**REVISED SCHEME DRAWING**

**1750 / 3B**

**PROPOSED EXTENSIONS AND ALTERATIONS AT " WESTWINDS ", ROUTE DE PLEINMONT, TORTEVAL, FOR :- R. PARR ESQ.**

**SITE PLAN**

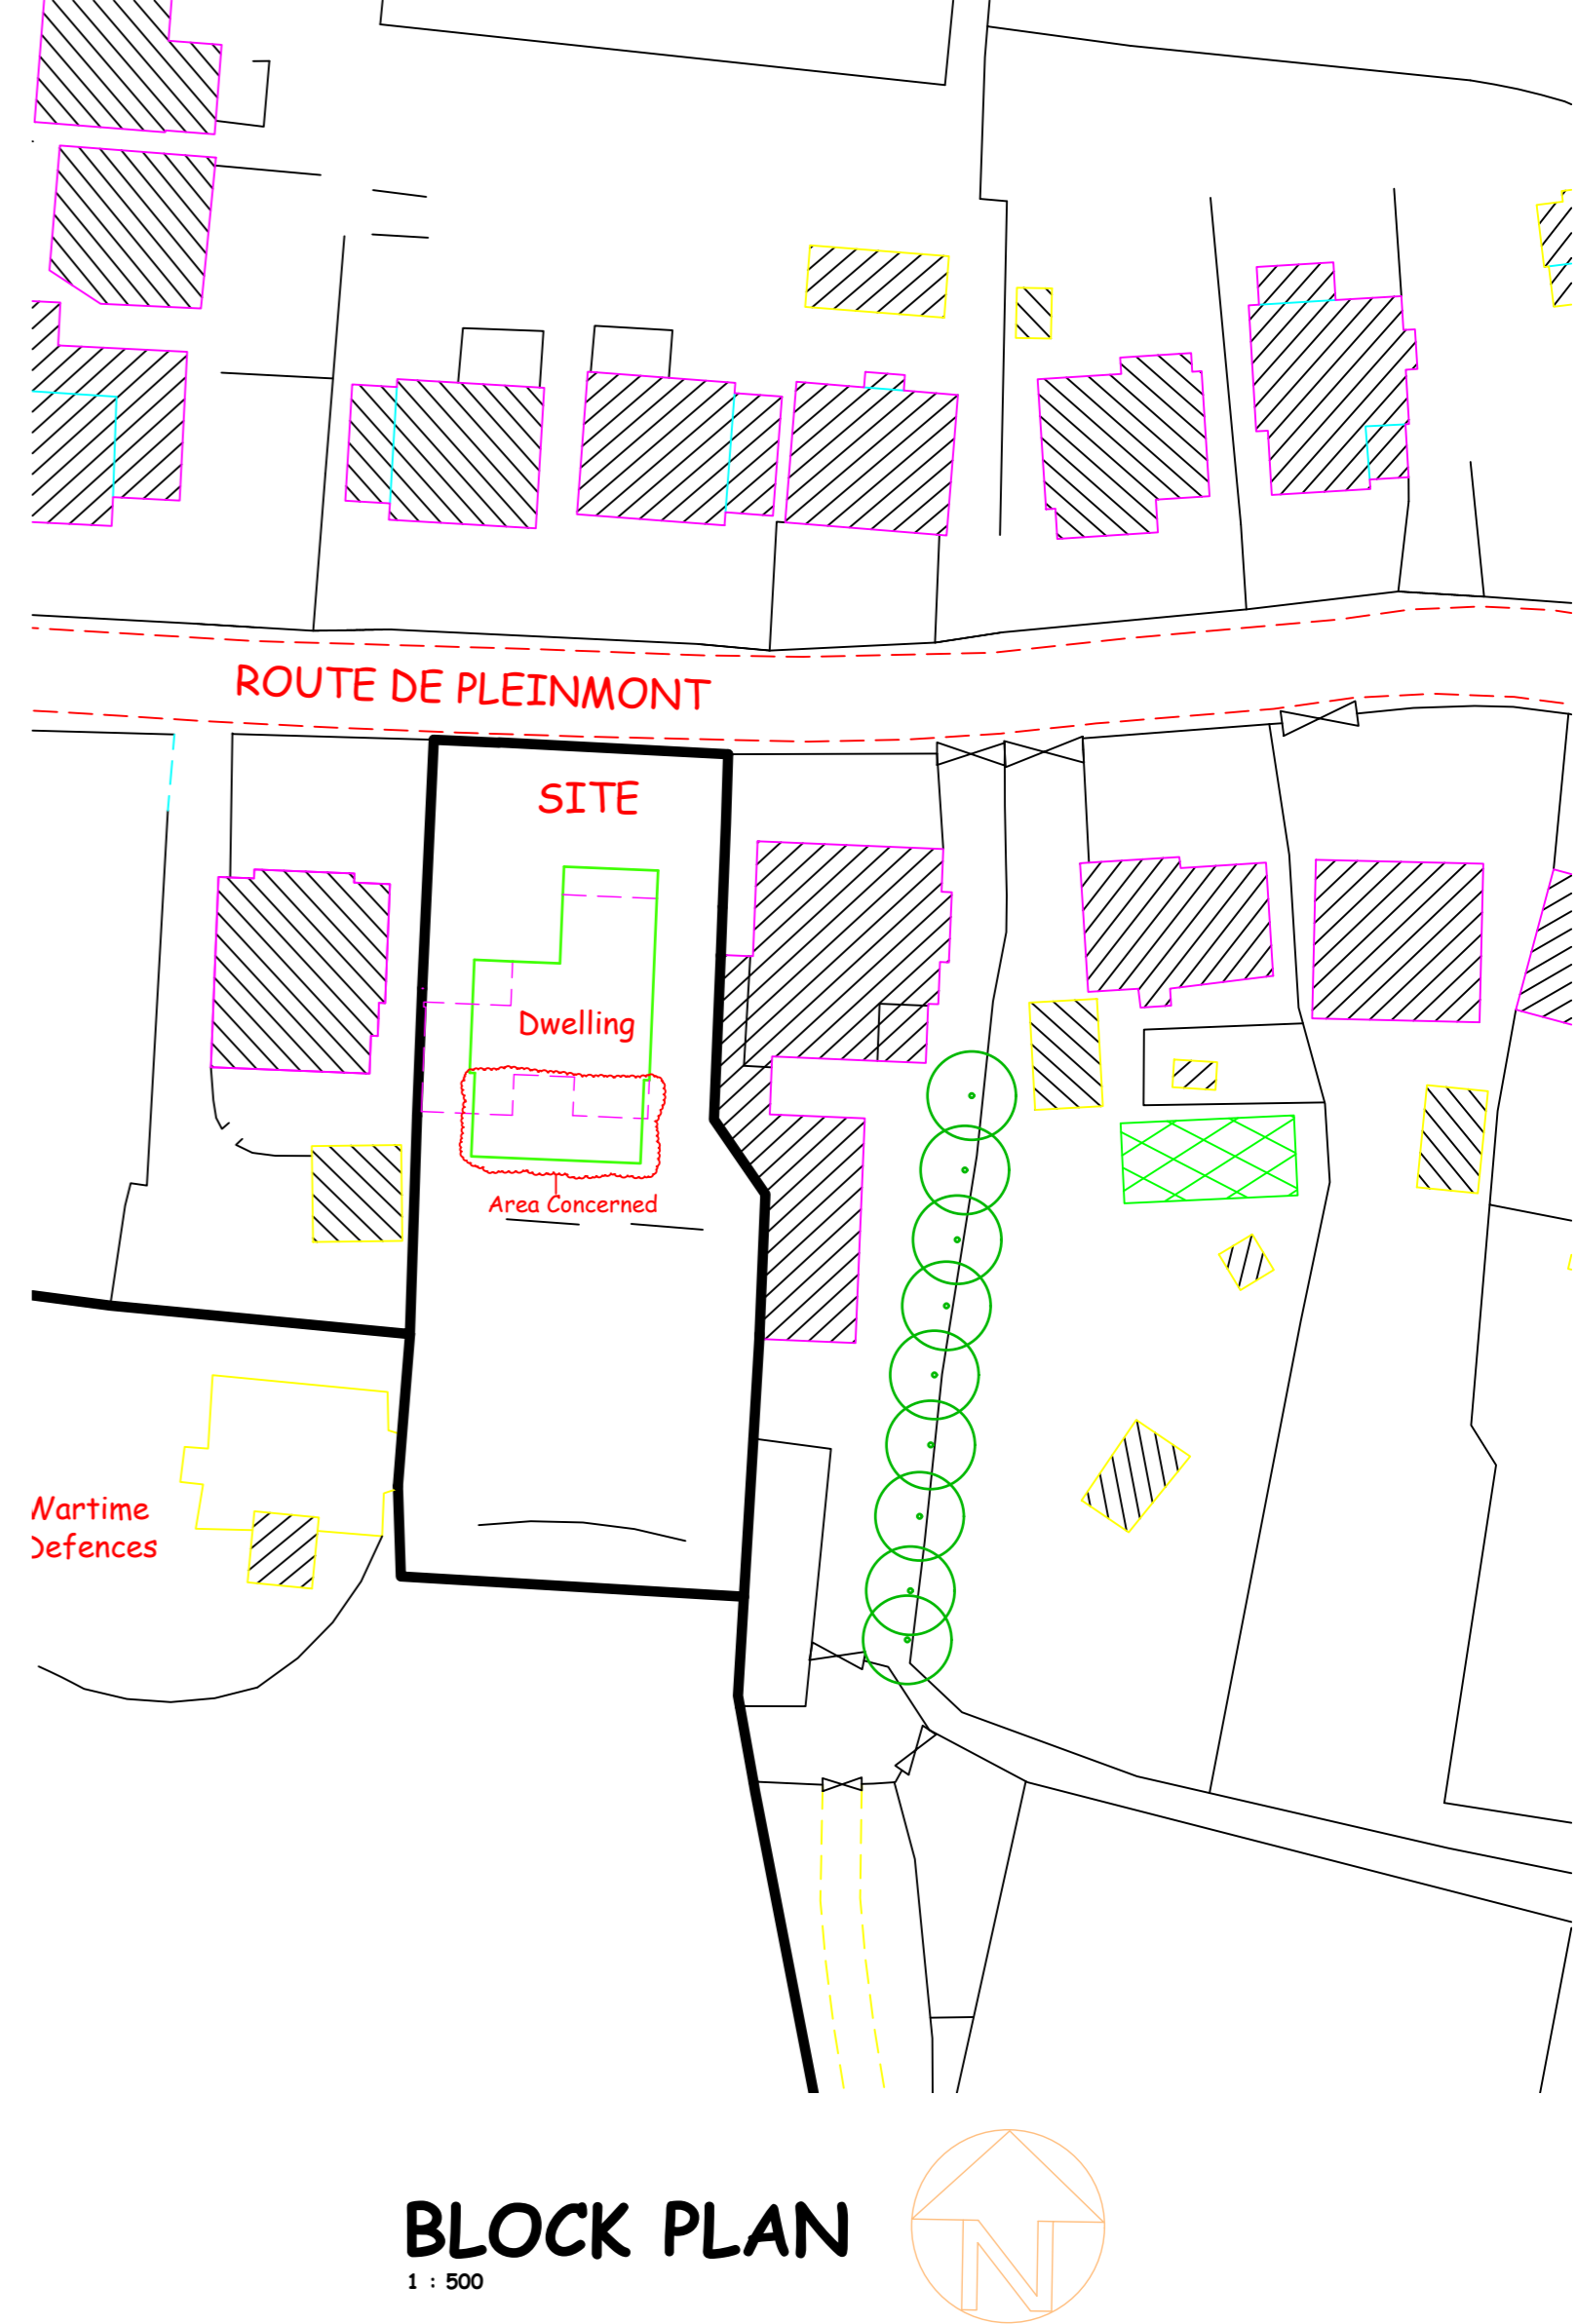
**REVISIONS**  
 A) Garage floor level dropped by 400mm to facilitate easier ramped vehicular access.  
 B) Side first floor rear balcony privacy screens reduced in height from 1800 to 1300 due to potential loss of sight lines from neighbouring properties.
